Access Compliance Report

Public Rights-of-Way

(Curb Ramps)

Intersection ID: 29992	Main Street: REIGATE_RD	Cross Street: KEMPSFORD_DR	Location: E
ADA ID: 2D055E83FFE2	Ramp Type: PerpDiag	Initial Pass/Fail: Fail	Overall Compliance: No
Severity Score: 8.75			
Codes/Mitigation Info/Possible Solution		Field Measurements/Component Compliance

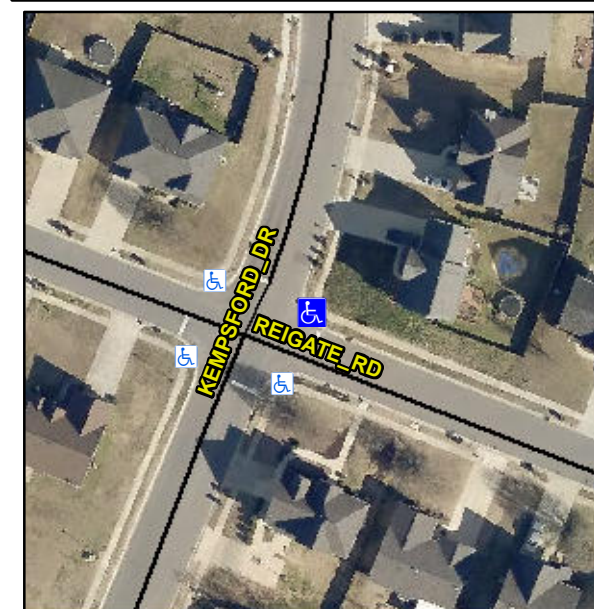
Not Found, R304.5.1

Compliance	Description	Data	Compliance	Description	Data
N/A	Ramp Length (in)	49.0	Yes	Ramp Slope (%)	7.9
No	Ramp Width (in)	42.0	Yes	Ramp XSlope (%)	1.9
N/A	Flare Type LT	N/A	N/A	Flare Type RT	N/A
N/A	Flare Slope LT (%)	N/A	N/A	Flare Slope RT (%)	N/A
N/A	Flare Traversable LT?	N/A	N/A	Flare Traversable RT?	N/A
N/A	Landing Length (in)	N/A	N/A	DWS Provided?	N/A
N/A	Landing Width (in)	N/A	N/A	DWS Contrast?	N/A
N/A	Landing Slope (%)	N/A	N/A	DWS Length (in)	N/A
N/A	Landing X Slope (%)	N/A	N/A	DWS Full Width?	N/A
N/A	Landing Curb? (Y/N)	N/A	N/A	DWS Offset (in)	N/A
N/A	Shared Landing?	N/A			
N/A	Gutter Ponding?	N/A	N/A	Gutter Slope (%)	N/A
N/A	Gutter Lip Ht (in)	N/A	N/A	Gutter X Slope (%)	N/A
N/A	Painted X Walk1?	No	N/A	Painted X Walk2?	No
	X Walk 1 Direction	To NW		X Walk 2 Direction	To SW
N/A	X Walk 1 Width (in)	N/A	N/A	X Walk 2 Width (in)	N/A
	X Walk 1 Slope (%)	0.7		X Walk 2 Slope (%)	1.4
	X Walk 1 X Slope (%)	1.8		X Walk 2 X Slope (%)	1.0

Remove & Replace Curb Ramp With Two New Directional Ramps or Equivalent.
